**Section 15**  
**SONAR SOUNDING EQUIPMENT**

**COMMUNICATION EQUIPMENT MAINTENANCE BULLETIN**

## SECTION 15. SONAR SOUNDING EQUIPMENT

FIGURE 1.—Correct wiring for CIP-55127 recorder of the NJ-8 equipment.

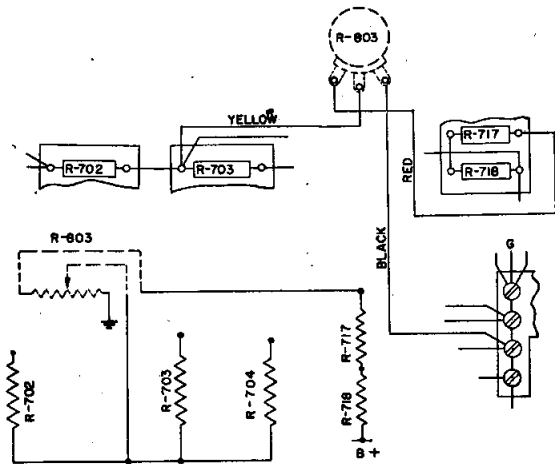
All vessels having Model NJ-8 sonar sounding equipment recorders, Navy type No. CIP-55127, or obtaining these units as a future installation, are requested to check the wiring to volume control R-803. The correct wiring and circuit arrangement are shown in Figure 1. A marked increase in amplifier sensitivity will occur when the wiring of the recorder is changed to agree with that shown in the illustration.

The NJ-8 recorders were apparently shipped from the factory with incorrect wiring in this circuit. Due to the fact that no new parts are required and no major rewiring is called for, no field change kit will be issued and no field change number will be assigned to this wiring change. 4/1/47

FIGURE 1.—Modification in NJ-8 receiver to eliminate intermittent flashing.

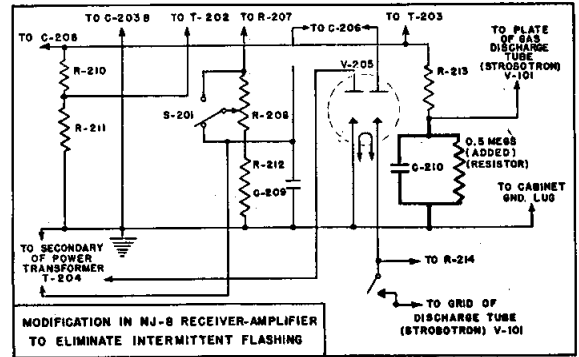
*General.*—Instances of erratic flashing due to excessive voltage on the plate of the strobotron tube V-101 have been reported. By placing a resistor across C-210 the voltage on the plate of V-101 is reduced sufficiently to prevent unwanted flashing.

*Procedure.*—Add the resistor across C-210 as indicated in Figure 1.

FIGURE 1.—Wiring changes in field change No. 2 on Model NJ-8 equipment.

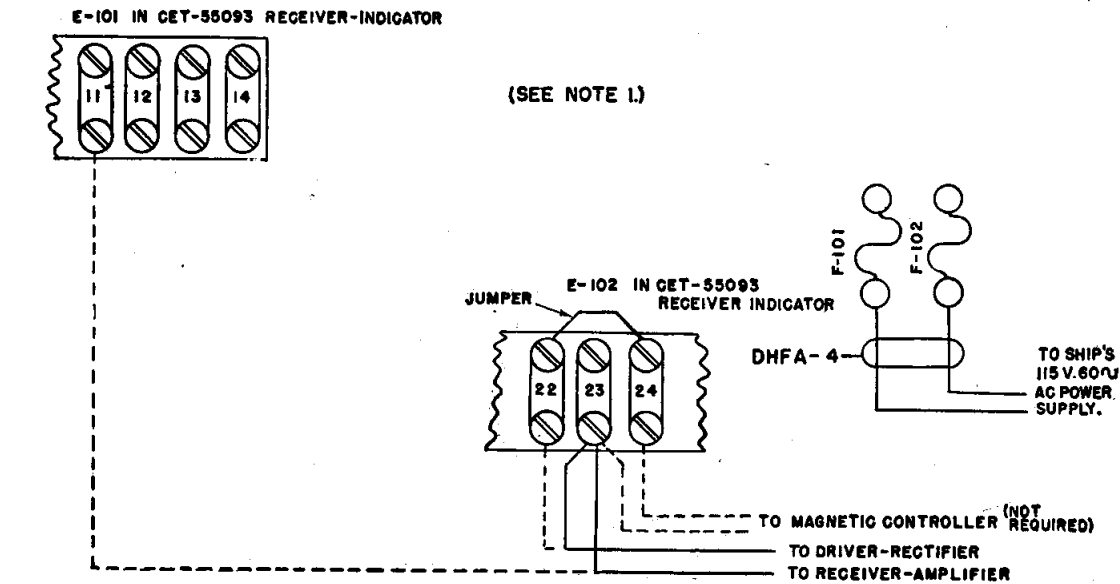
*General.*—The NJ-8, as shipped, is wired for operation from a magnetic controller and a motor-alternator set as used on vessels having a d-c supply. Since the equipment itself may be operated without the motor-alternator from a 115-volt, 60-cycle, a-c power supply, numerous installations without use of a motor-alternator have been made on vessels supplied with a-c power. Usually in these instances an external switch has been installed between the ship's power panel and the equipment. It has been reported that occasionally this external switch was left on when the equipment was not

in use. Thus, power remained on the receiver-amplifier and driver-rectifier units even though the equipment power switch was in the OFF position. In order to eliminate this possibility

the internal wiring of all NJ-8 equipments operating directly from ship's a-c supply should be modified in accordance with this field change.

1—Disconnect the internal lead to the receiver-amplifier at terminal #11 on terminal strip E-101 in the receiver-indicator. Reconnect this wire to terminal #23 on terminal strip E-102.

2—Disconnect the external lead to the driver-rectifier at terminal #22 on terminal strip E-102. Reconnect this wire to terminal #23 on terminal strip E-102.

3—Insert a jumper between terminals #22 and #24 on terminal strip E-102.

4—Connect the 115-volt, 60-cycle, single phase power leads directly to the terminals on the lower ends of F-101 and F-102.

FIGURE 2.—Switch plate lay-out for field change No. 2 on Model NJ-8 equipment.

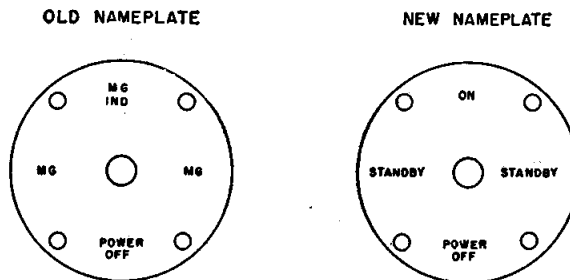
1—Fabricate a laminated bakelite or a brass switch plate. The new plate is to be the same size as the original and engraved or stamped as indicated.

2—Remove the control knob from the power switch S-102.

3—Replace the present switch plate with the new switch plate.

4—Replace the control knob.

FIGURE 1.—Revised schematic to eliminate misfiring of discharge unit assembly in Model NK-2 equipment.

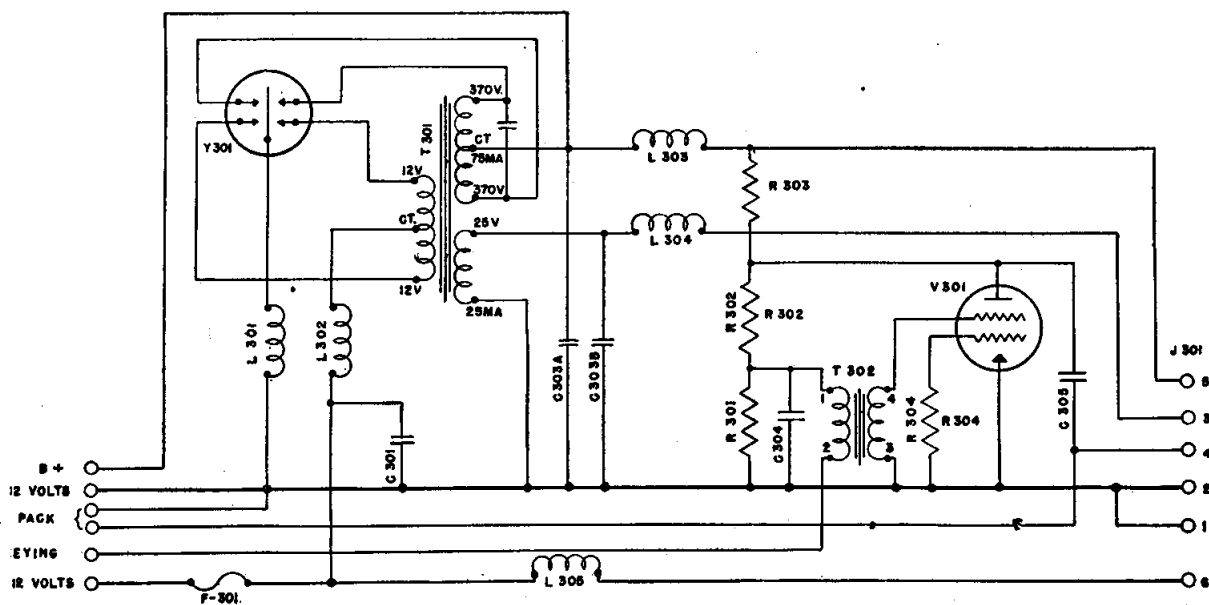
*General.*—It has been found that the power supply voltage of the NK-2 is slightly too high for the discharge tube V-301. This condition causes the tube to fire without application of the keying voltage. By relocating R-303 in accordance with this field change, the voltage is sufficiently reduced to eliminate misfiring.

1—Remove the connection between R-302 and L-303.

2—Disconnect R-303 presently located between the plate of V-301 and the junction of L-303 and R-302. Reconnect R-303 between R-302 and L-303.

3—Connect the plate of V-301 to the junction of R-303 and R-302.

FIGURE 1.—Connections to cable plug P-403 in Model NMC equipment.

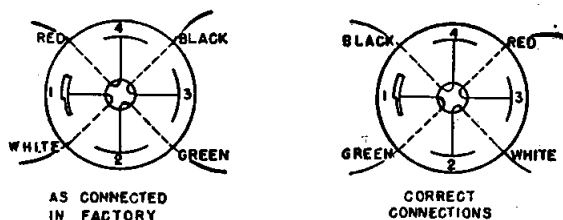
*General.*—The units which this change affects were delivered with non-standard wiring of the receptacle J-403 and its associated cable plug P-403. With these connections the units operate satisfactorily, but are not interchangeable with similar units of different serials. This change, by providing standard wiring of J-403 and P-403, permits complete interchangeability of units.

*Procedure.* 1—Change connections to cable plug P-403 as shown in Figure 1.

Figure 1.—Filter junction box (W. T.) NMC sonar field change No. 7 revision.

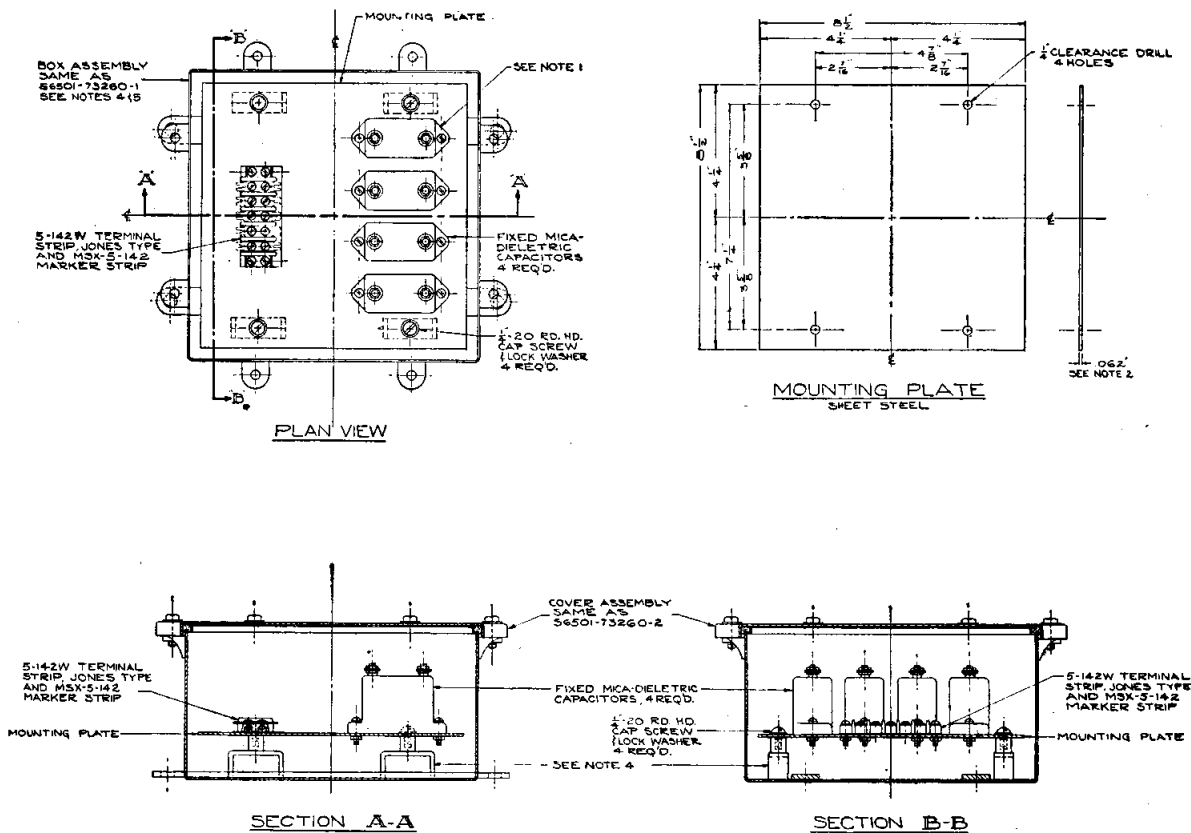
*Material required.*—1—One rectangular watertight enclosure as shown on ➡ BuShips drawing RE 53F 2000A. (See Figure 1 on the next page.) If above enclosure is not available an equivalent type box may be supplied.

*General.*—The type CRV-53137 filter junction box supplied as a unit of the NMC equipment is not of a watertight construction. Flooding of the compartment in which the filter junction box is installed or excessive moisture condensation within the box will damage the capacitors and short the driver output. This change prevents the water damage by providing a watertight filter junction box.

➡ These W. T. Box assemblies will contain a lightning arrestor on a mounting plate which is to be removed and a new mounting plate cut from sheet steel. Mounting brackets are provided that should reduce the time of fabrication and assembly. ←

- 1—Remove the present filter junction box.
- 2—Mount the watertight enclosure.
- 3—Remove the capacitors and the terminal board from the old box. Reinstall them in the new box.
- 4—Install the stuffing tubes. Pack to make watertight.
- 5—Reconnect former wiring.

FIGURE 2.—Side view of a Model NMC transducer showing exposure of the bottom of a bolt hole by the removal of material from the transducer face.

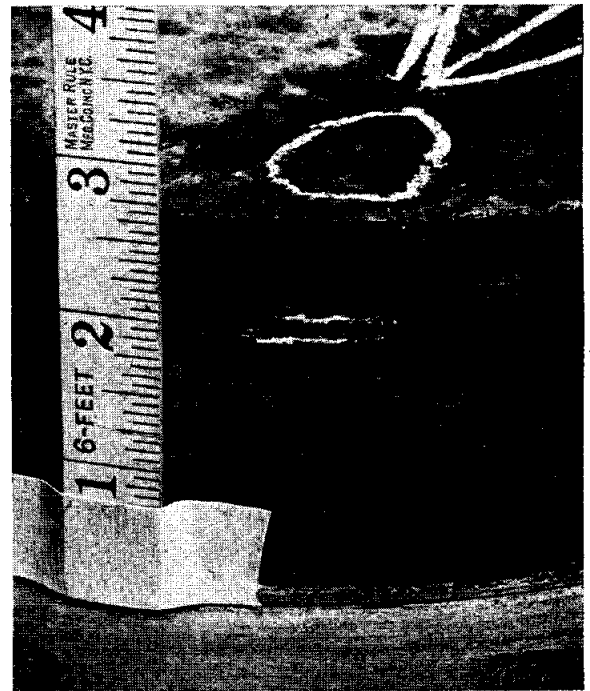
The attention of all activities is called to the supply of model NMC Field Change No. 8 Kits at all stock activities. In cases of excessive pitting, replacement of diaphragms should be made and in no instance should the diaphragm be reduced in thickness. 4/1/50

FIGURE 1.—Parasitic suppressor for the Model NMC-1 equipment.

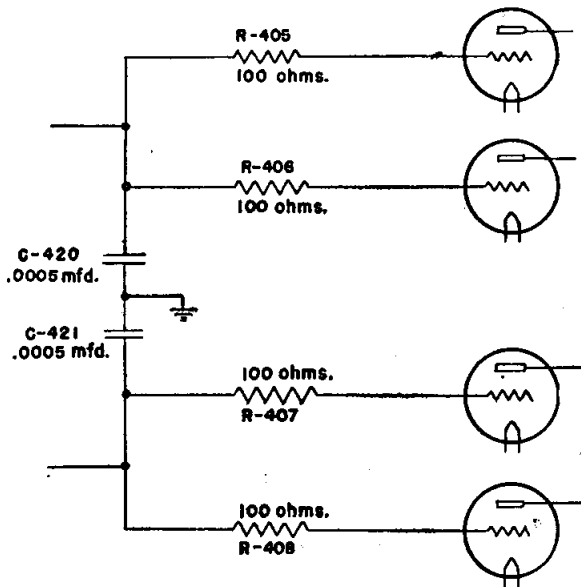
*General.*—Spurious oscillations occasionally take place in the final amplifier of the driver. This field change alters the circuit constants by adding capacitors between the suppressor resistors and ground. Thus the amplifier oscillations are eliminated and the plate current becomes normal.

*Changes in instruction books.*—No changes are necessary as the added capacitors, labeled C-420 and C-421, are shown in schematic 60,247 alt. 8, of "Preliminary Instruction Book for NMC-1 Echo Sounding Equipment", spec. 8352B, second printing.
